## **CRABTREE PLACE SUBDIVISION**

APPLICATION NUMBER 14 DATE August 18, 2005  
APPLICANT Crabtree Place Subdivision  
REQUEST Subdivision

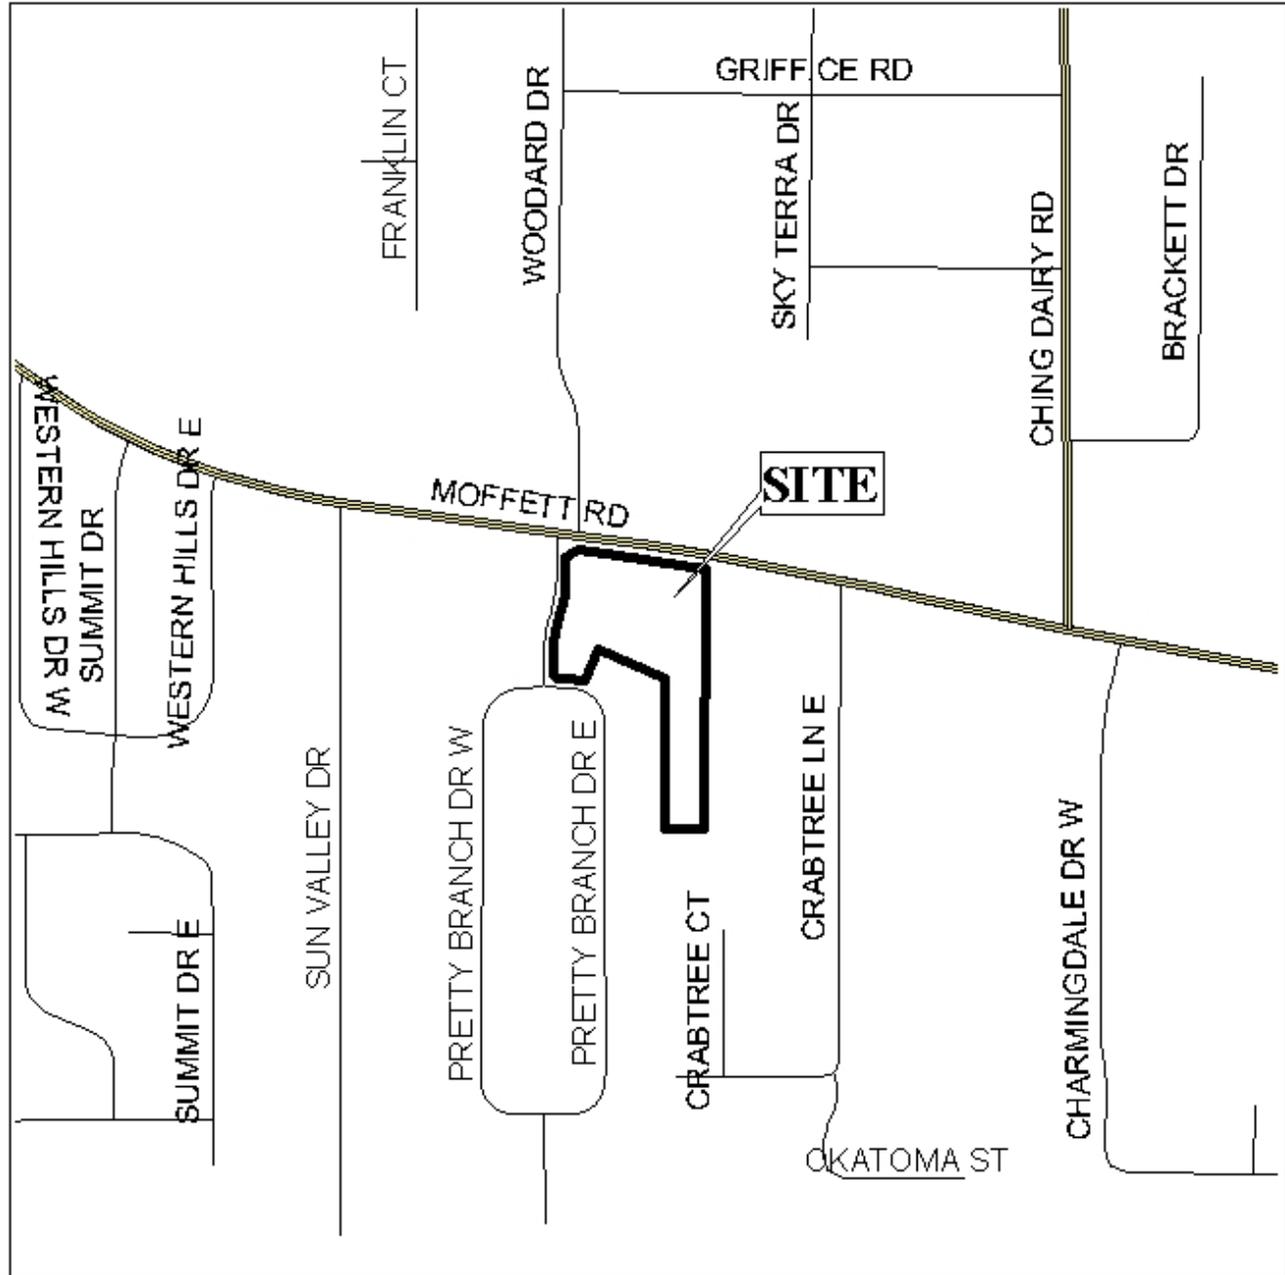
The plat illustrates the proposed 2 lot, 5.7 ± acres subdivision which is located on the East side of Spanish Oak Drive, extending from Moffett Road to Pretty Branch Drive East. The subdivision is served by public water and sanitary sewer.

The site fronts Moffett Road, a planned major street, which has an existing right-of-way of 80-feet; the Major Street Plan requires a 100-foot right-of-way. Therefore, the dedication of adequate right-of-way to provide 50-feet from the centerline of Moffett Road should be required. Additionally, as a means of access management, Lot 1 should be limited to two curb cuts to Moffett Road, with the size, location and design to be approved by County Engineering, and denied access to Spanish Oak Drive; and, Lot 2 should be limited to one curb cut to Spanish Oak Drive, with the size, location and design to be approved by County Engineering and denied direct access to Pretty Branch Drive East.

This site is located in the County, thus a note should be placed on the final plat stating that any lots which are developed commercially and adjoin residentially developed property must provide a buffer, in compliance with Section V.A.7. of the Subdivision Regulations.

The plat meets the minimum requirements of the Subdivision Regulations and is recommended for Tentative Approval subject to the following conditions: 1) the dedication of sufficient right-of-way to provide 50-feet from the centerline Moffett Road; 2) the placement of a note on the final plat stating that Lot 1 is limited to two curb cuts to Moffett Road, with the size, location and design to be approved by County Engineering and Lot 2 is limited to one curb cut to Spanish Oak Drive, with the size, location and design to be approved by County Engineering; 3) the placement of a note on the final plat stating that Lot 1 is denied direct access to Spanish Oak Drive and Lot 2 is denied direct access to Pretty Branch Drive East; and 4) the placement of a note on the final plat stating that any property that is developed commercially and adjoins residentially developed property shall provide a buffer, in compliance with Section V.A.7. of the Subdivision Regulations.
